UNITED STATES PATENT AND TRADEMARK OFFICE

10/664,443

Office Action Summary	Application No. 10/664,443	Applicant(s) SERKH, ALEXANDER	
	Examiner Vicky A. Johnson	Art Unit 3656

DETAILED ACTION

Schmid US 6,039,664

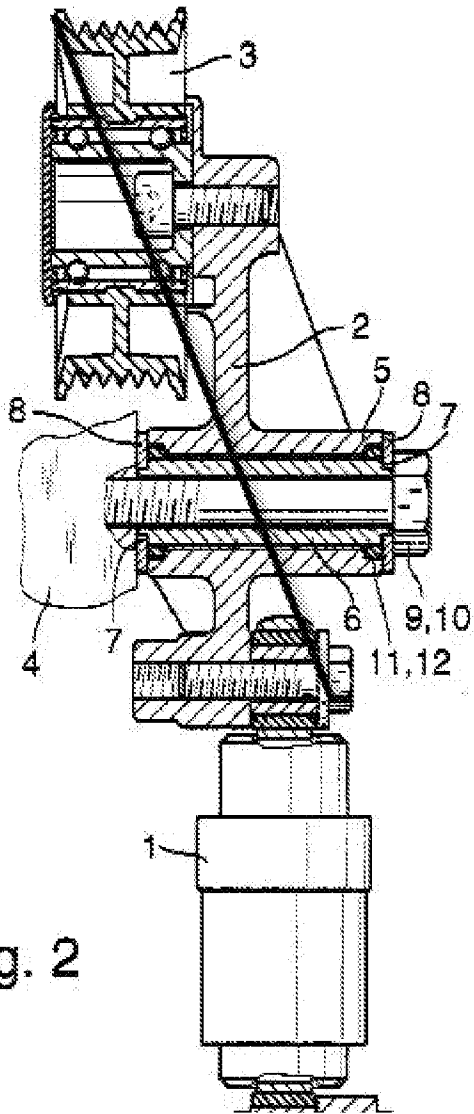
Schmid discloses an improved power transmission belt tensioner of the type having a pulley (3) adapted to communicate with a surface of a power transmission belt, an arm (2) supporting said pulley upon which said pulley is rotatably mounted via a pulley bearing (see Fig 2), a shaft (5) supporting said arm, said shaft rotatably supported by a pivot bearing (13), an attachment point (see Fig 2) for a strut (1), and said strut attached to said attachment point (see Fig 2), the improvement comprising: said pulley (right side) and said attachment point (left side) laterally offset in relation to said pivot bearing such that a balance line (see Figure attached below) passing through an axis of said attachment point and a center of said pulley intersects said shaft within a lateral limit of said pivot bearing, thereby substantially balancing said tensioner in terms of parasitic torque across said pivot bearing (It is inherent that the forces of the strut would balance out the forces of the pulley, because as the belt applies more force against the pulley the strut would apply an equal opposite force in order to keep tension

Re claim 2, said strut attachment point is laterally opposite of said pivot bearing in relation to the plane of rotation of said pulley (see Fig 2).

Re claim 3, said strut attachment forms part of a member (2) extending from a support for said pulley bearing (see Fig 2).

Re claim 5, said strut attachment point is laterally opposite of said pulley in relation to the plane of rotation of said pivot bearing (see Fig 2).

Re claim 6, said strut attachment point is beyond the lateral limits of said pivot bearing (see Fig 2).

Re claim 7, said strut attachment forms part of a member (2) extending from said shaft (see Fig 2).

Re claim 8, the plane at the center of rotation of said pulley is beyond the lateral limits of said pivot bearing (see Fig 2).

Re claim 9, said pulley is radially opposite of said attachment point in relation to said pivot bearing (see Fig 2).

The applicant argues that the above-cited references fail to meet the limitations of the claims because they fail to disclose a balance line passing through an axis of the attachment point and a center of said pulley intersects the shaft within a lateral limit of the pivot bearing. The two figures attached below each show a balance line passing through an axis of said attachment point and a center of said pulley intersects said shaft within a lateral limit of said pivot bearing.

Mutoh et al US 4,838,840

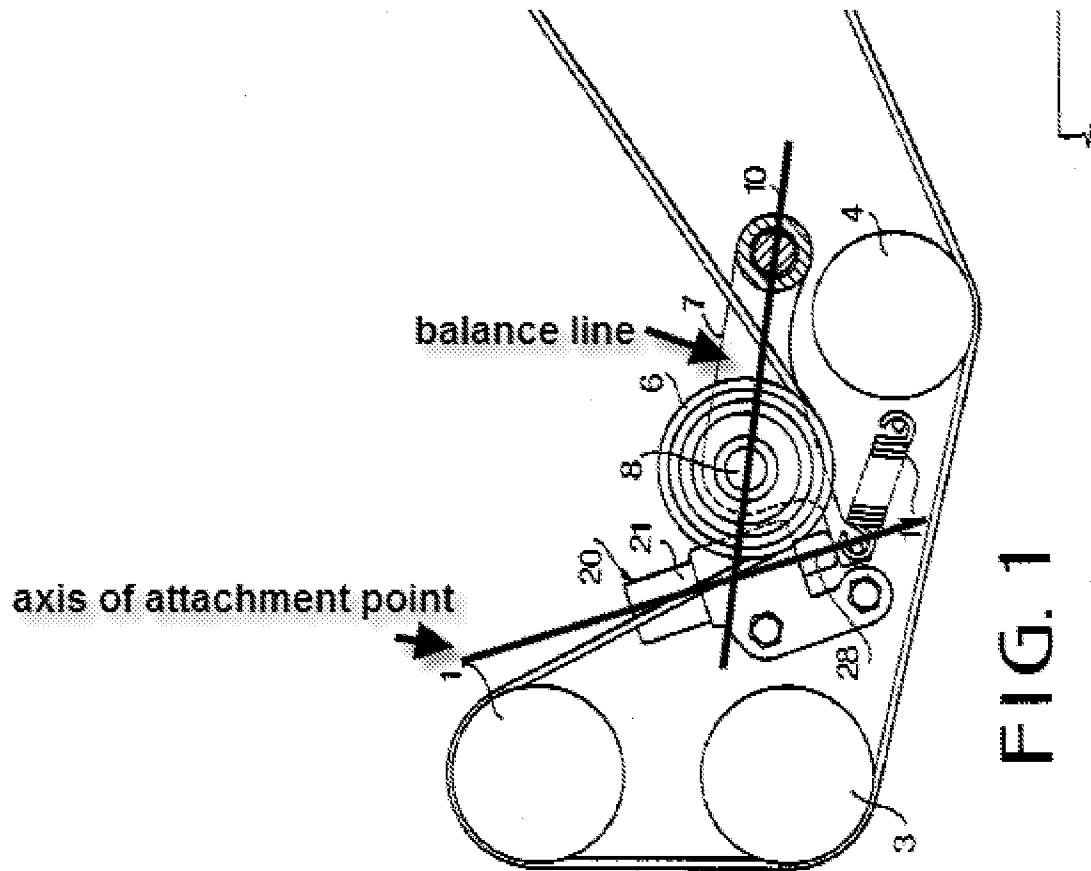
Mutoh et al disclose a power transmission drive comprising; a crankshaft pulley (1); an accessory pulley (3); a power transmission belt (5); a power transmission belt tensioner having a tensioner pulley (6) adapted to communicate with a surface of said power transmission belt (see Fig 1), an arm (7) supporting said tensioner pulley upon which said tensioner pulley is rotatably mounted via a pulley bearing (9), a shaft (10) supporting said arm, said shaft rotatably supported by a pivot bearing (unnumbered, see Fig 2), an attachment point (unnumbered, see Fig 1) for a strut (21), and said strut attached to said attachment point (at 28), said pulley and said attachment point laterally offset in relation to said pivot bearing such that a balance line passing through an axis of said attachment point and a center of said pulley intersects said shaft within a lateral limit of said pivot bearing (see Mutoh et al Figure attached below), thereby substantially balancing said tensioner in terms of parasitic torque across said pivot bearing (It is inherent that the forces of the strut would balance out the forces of the pulley, because as the belt applies more force against the pulley the strut would apply an equal opposite force in order to keep tension on the belt. The forces of the pulley and the strut have to pass through the pivot bearing and balance in order to keep the appropriate tension on the belt) and, said power transmission belt trained about said crankshaft pulley, said accessory pulley and said tensioner pulley (see Fig 1).

Re claim 22, Mutoh et al disclose method of tensioning a power transmission belt comprising: providing said power transmission belt (5), providing a pivot bearing (unnumbered see Fig 2), providing a tensioner having a pulley (6) adapted to communicate with a surface of said power transmission belt (see Fig 2), a supporting structure (7) including a supporting shaft (10) rotatably supported by said pivot bearing for supporting a supporting arm (see Fig 2), said supporting arm for supporting said pulley (see Fig 2), said pulley being rotatably mounted upon said supporting arm via a pulley bearing (9), said pulley being laterally offset in relation to said pivot bearing (see Fig 2), and an attachment point (at 28) for a strut (21), said attachment point being laterally offset in relation to said pivot bearing such that a balance line passing through an axis of said attachment point and a center of said pulley intersects said shaft within

a lateral limit of said pivot bearing (see Mutoh et al Figure attached below), communicating a biasing force from said strut to said attachment point (at 28), said supporting structure (7) communicating said biasing force to said pulley through rotation about said pivot bearing (10), and substantially balancing said biasing force at said pivot bearing in terms of parasitic torque (It is inherent that the forces of the strut would balance out the forces of the pulley, because as the belt applies more force against the pulley the strut would apply an equal opposite force in order to keep tension on the belt. The forces of the pulley and the strut have to pass through the pivot bearing and balance in order to keep the appropriate tension on the belt).
